What this review needs to decide

Current proposal to challenge

Main: diameter 220 mm, centered upright capsule 116.35 x 151.10 mm, end radius 58.175 mm. Diverter: 124 mm outside / 80 mm inside; 120 mm fallback. Stock: 1.524 mm metal or matching plastic; separate 3 mm plastic trial. No locators in the present files.

Inner plate measured face

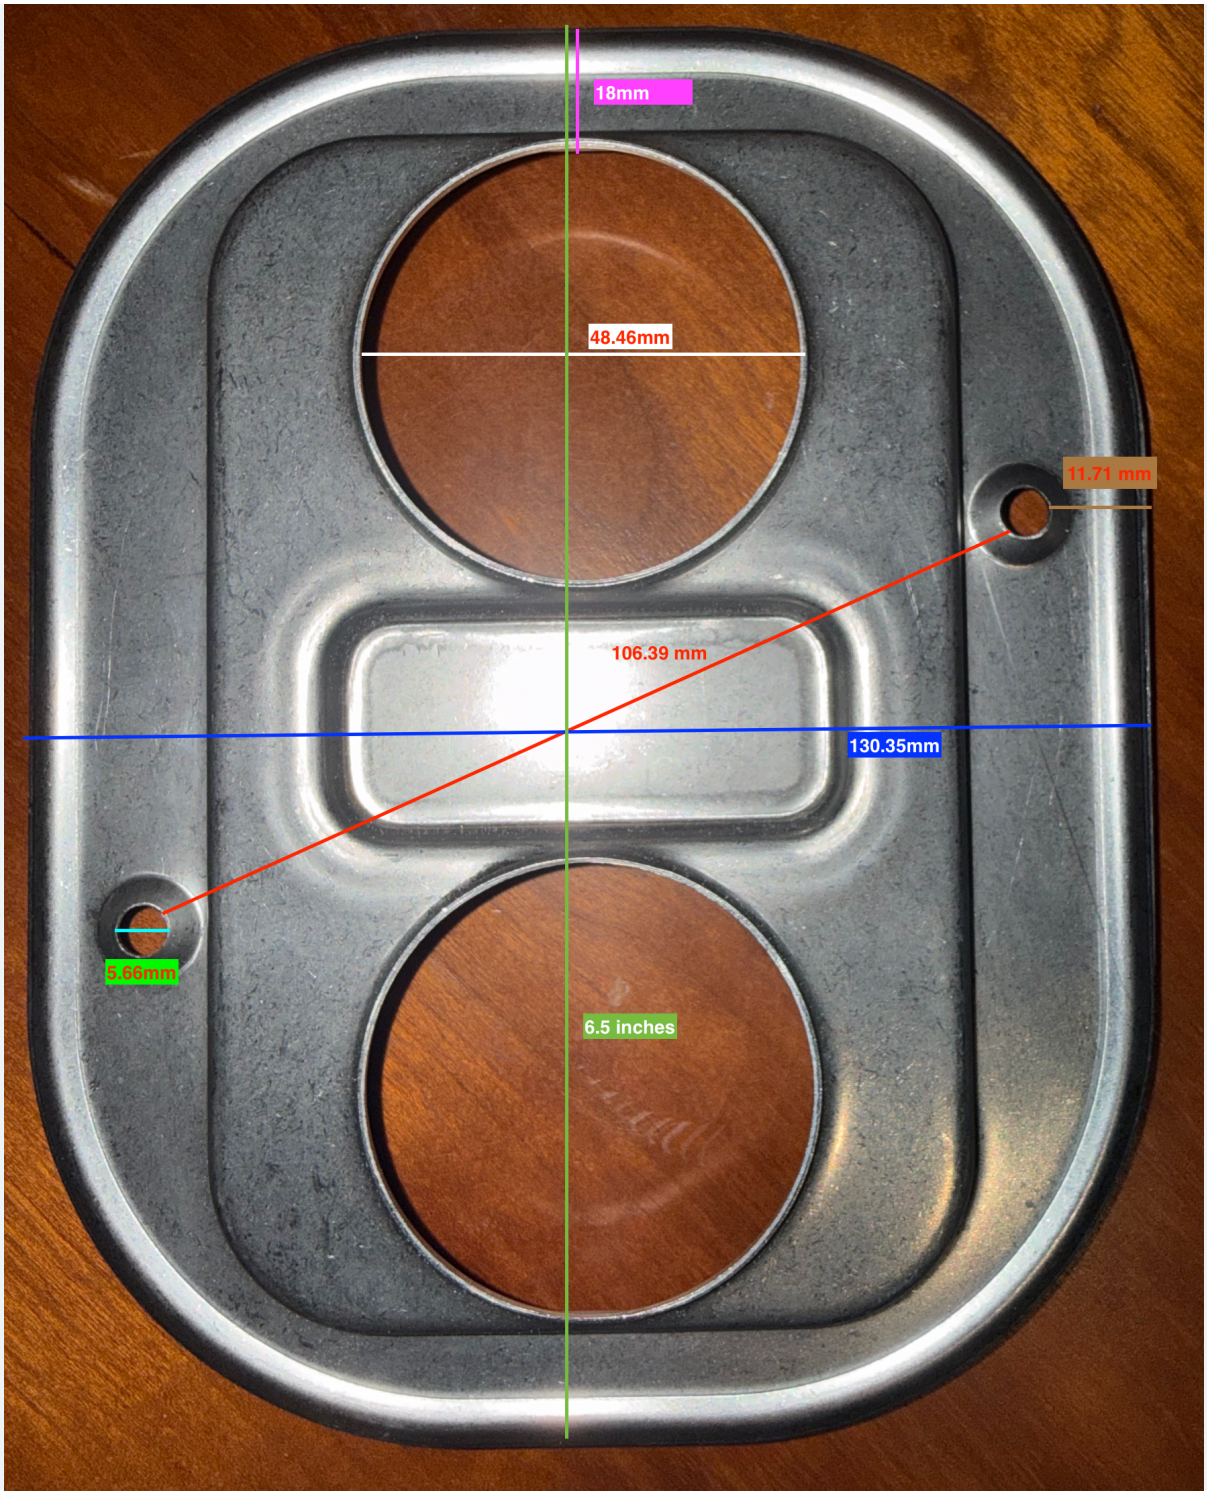
Measured within one plane; the owner considers the caliper readings highly accurate. No tip-depth correction applies. Width 130.35 mm; upper opening 48.46 mm; tape height 165.10 mm.

106.39 mm is nearest-hole-edge gap; 11.71 mm is hole edge to outside rim; SW hole is 5.66 mm; NE diameter is unknown. Use the calipers ahead of scan estimates for these measured dimensions. Foam/depth readings are separate; no numerical accuracy bound was supplied.

Decorative cover measured face

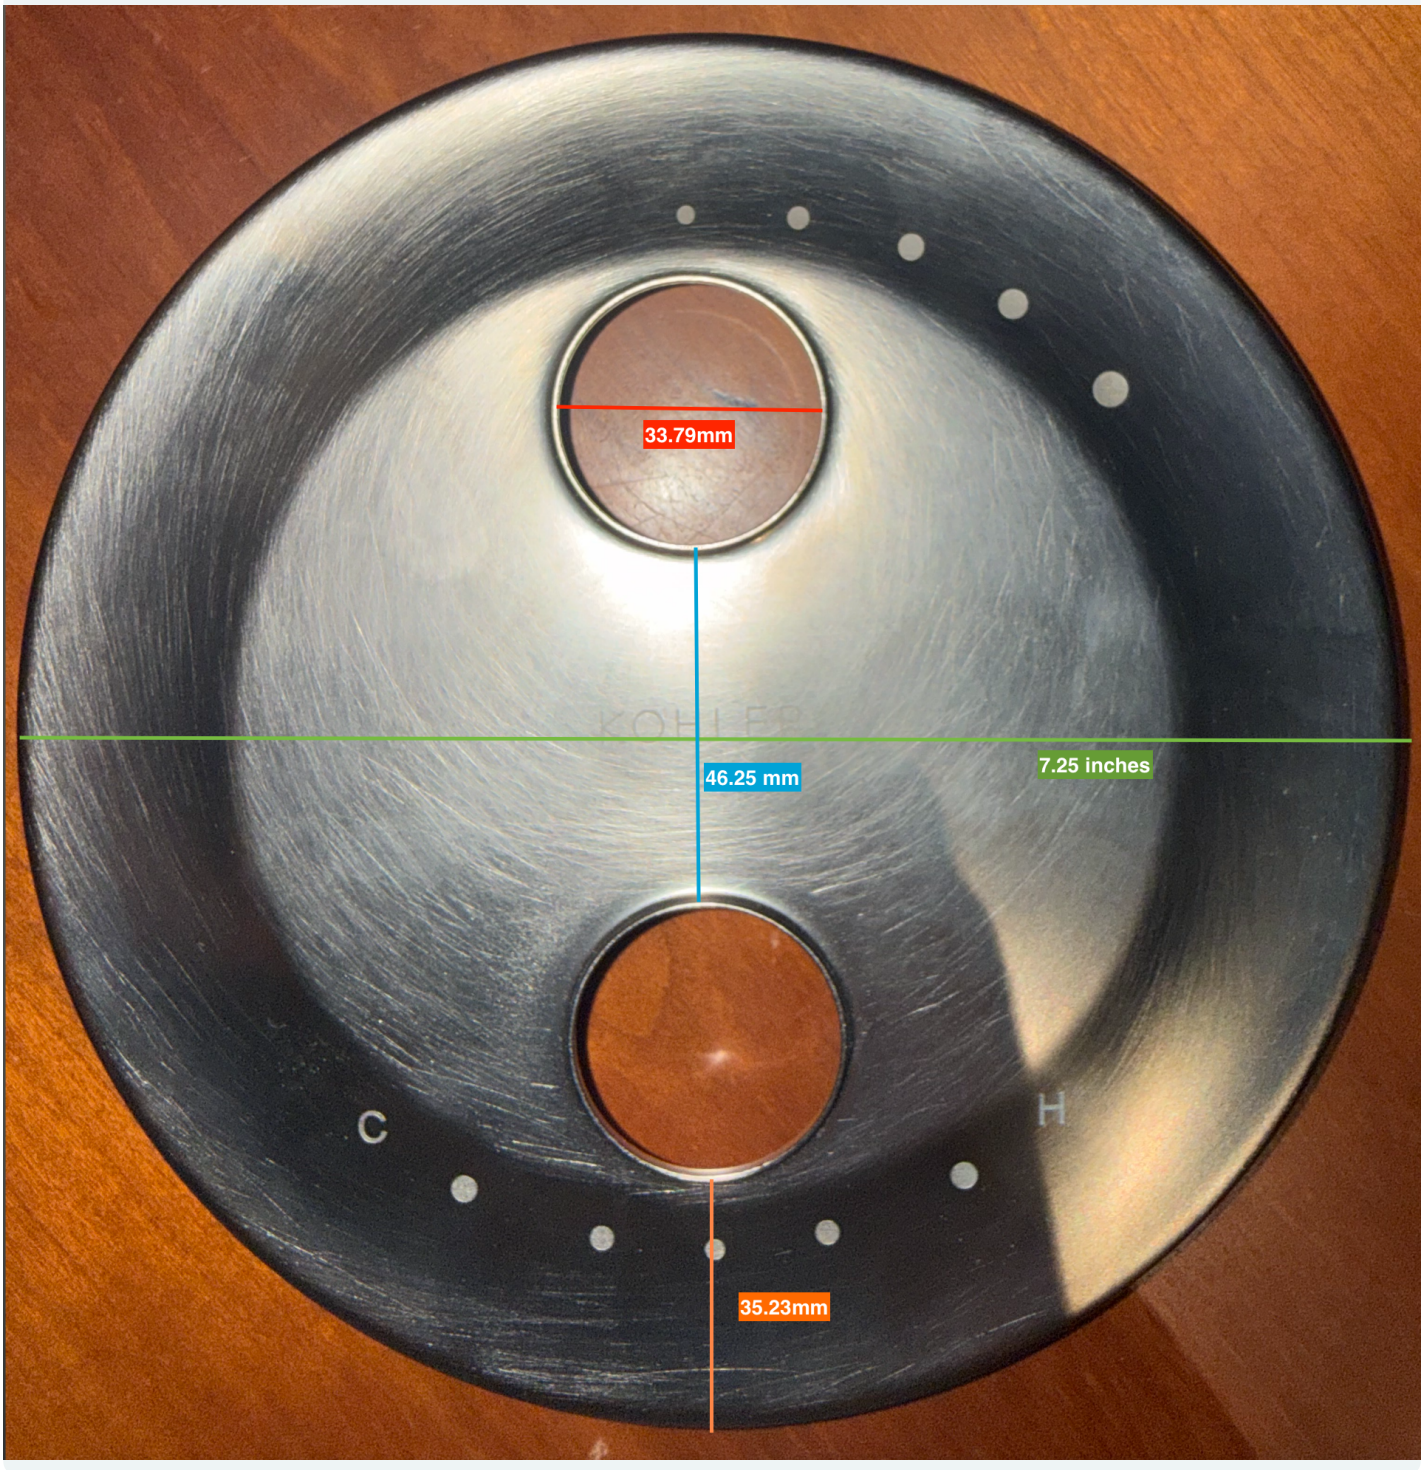
Outside diameter 7.25 inches = 184.15 mm. Upper opening 33.79 mm. The blue 46.25 mm is between nearest inside opening edges. Orange 35.23 mm runs from lower inside opening edge to outside bottom rim.

Lower opening diameter and rear cavity are unmeasured. These front dimensions do not establish nut clearance, handle engagement or the installed center.

Current main aperture

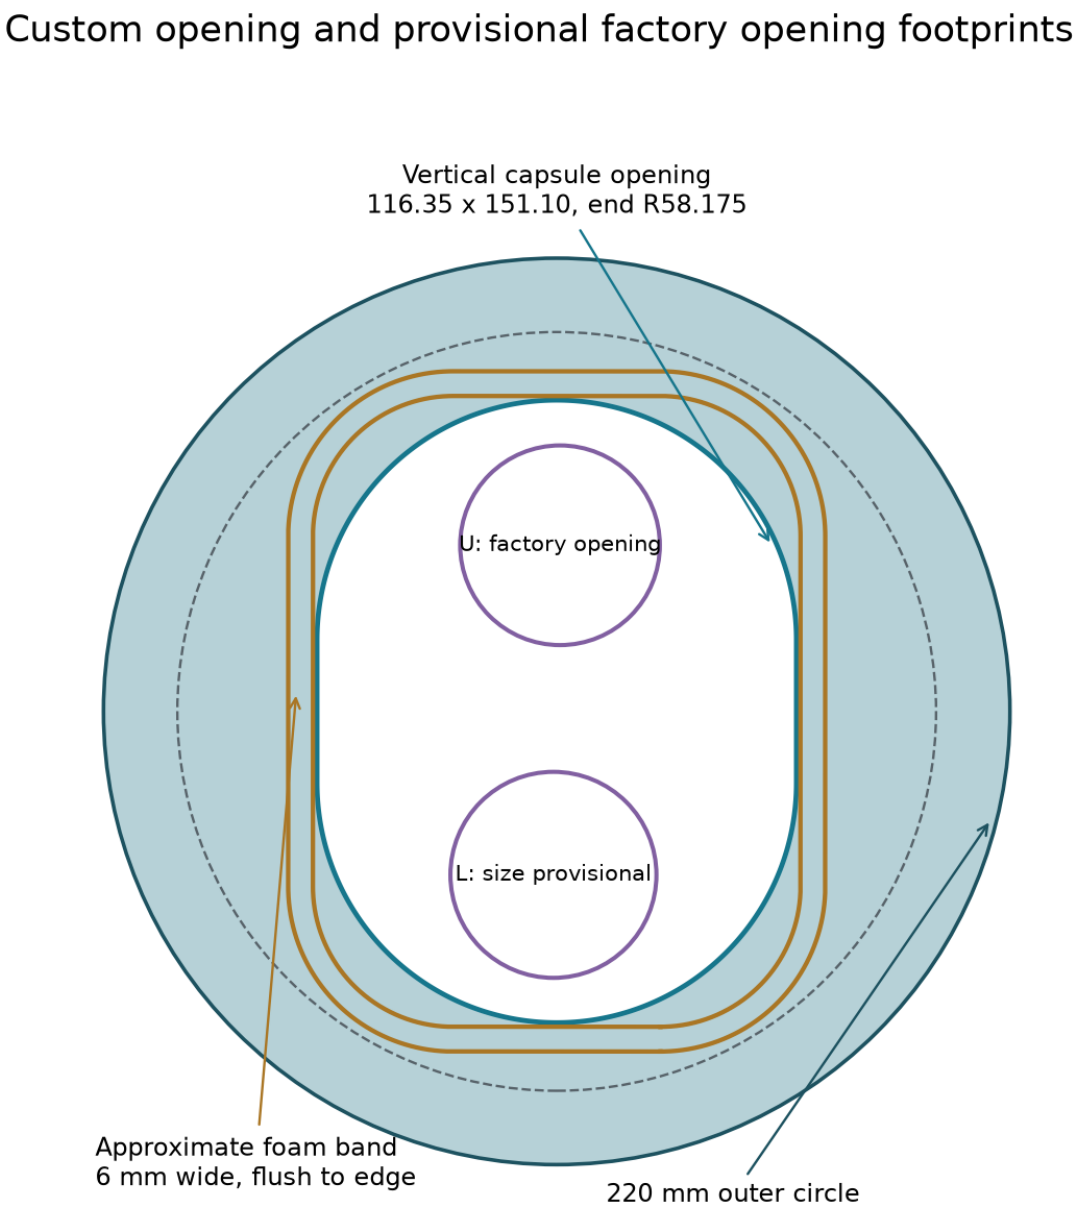
Gold is a nominal footprint, not a verified seal. 1.00 mm extra land inside the assumed foam.
Purple circles belong to the factory inner plate; they are not extra holes cut in this part.

Main outside diameter 220 mm; centered vertical capsule 116.35 x 151.10 mm with R58.175 ends. Gold represents assumed edge-flush foam. The lower opening circle and some placement dimensions remain assumptions.

The nominal extra land inside the 6 mm foam is only 1 mm. The smallest scoped projected hardware clearance is about 1.61 mm before unresolved scan/placement errors. These are review targets, not accepted field tolerances.

Main and diverter size choice

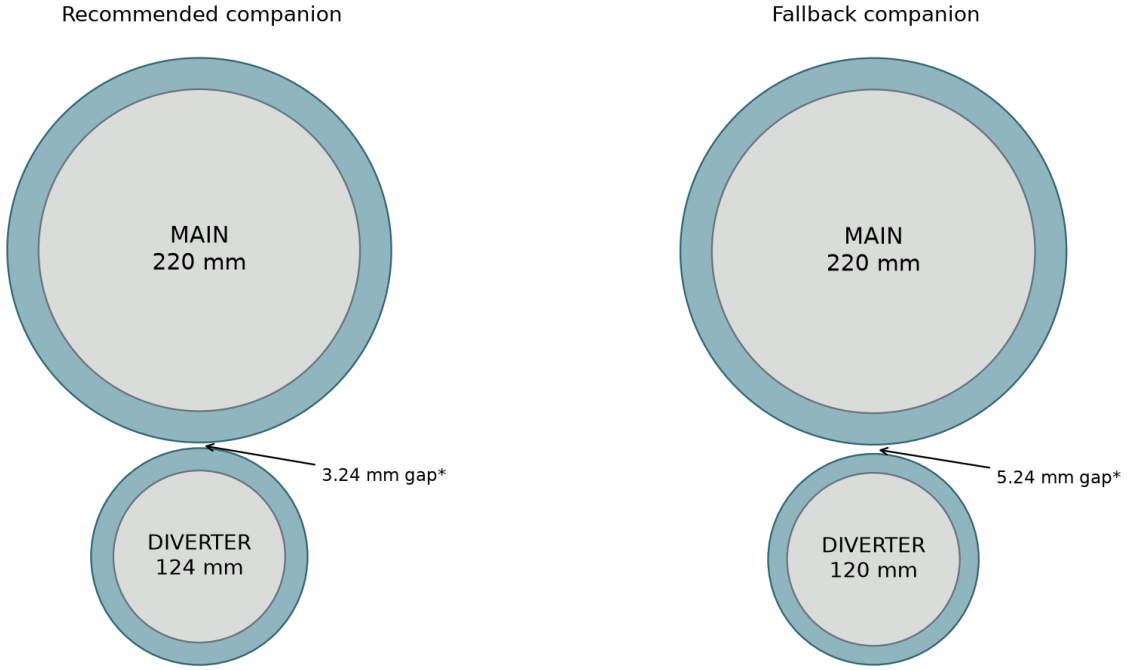
*Original placement estimate. Across recorded scenarios, selected-pair gap is 3.06-5.21 mm, not error bounds. Increasing either diameter consumes half that increase from the gap. Verify with both real covers.

Earlier placements predict only about 3-5 mm between the larger pair. These are scenarios, not an uncertainty range. The actual diverter seal footprint and paired clearance need the expert fit trial.

Recommended trial: main 220 mm and diverter 124/80 mm. The separate diverter fallback is 120/80 mm. Keep both backing circles concentric with their actual covers.

Earlier locating-tab experiment

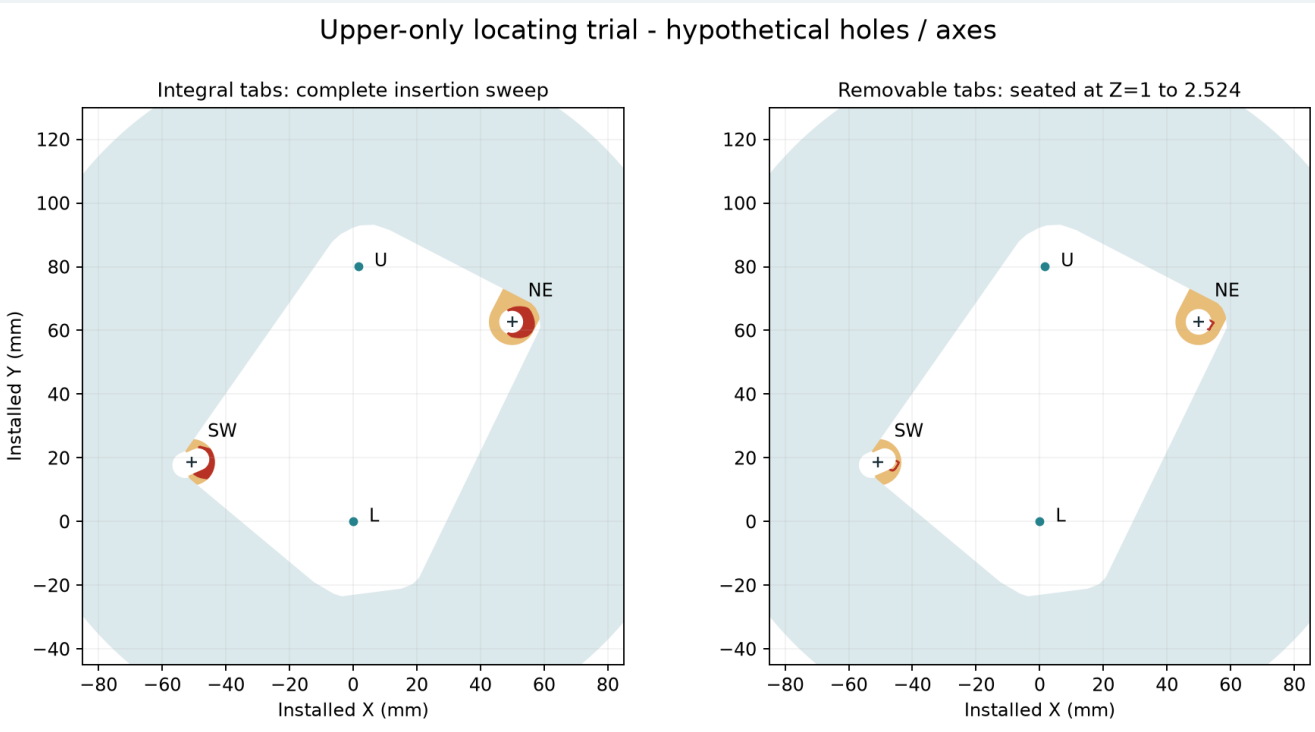
Amber: added tab metal. Red: projected captured-surface interference. Not a released mounting design.

This earlier diagonal opening added metal tabs with hypothetical holes/axes. Red marks conditional captured-surface interference in insertion or seated trials. It is not the FT01 capsule design.

The trial does not rule out every notch. A notch removes material; a tab adds it. Pro should independently assess restraint, adjustment, foam land, bearing, depth and complete insertion/removal before recommending a locator variant.
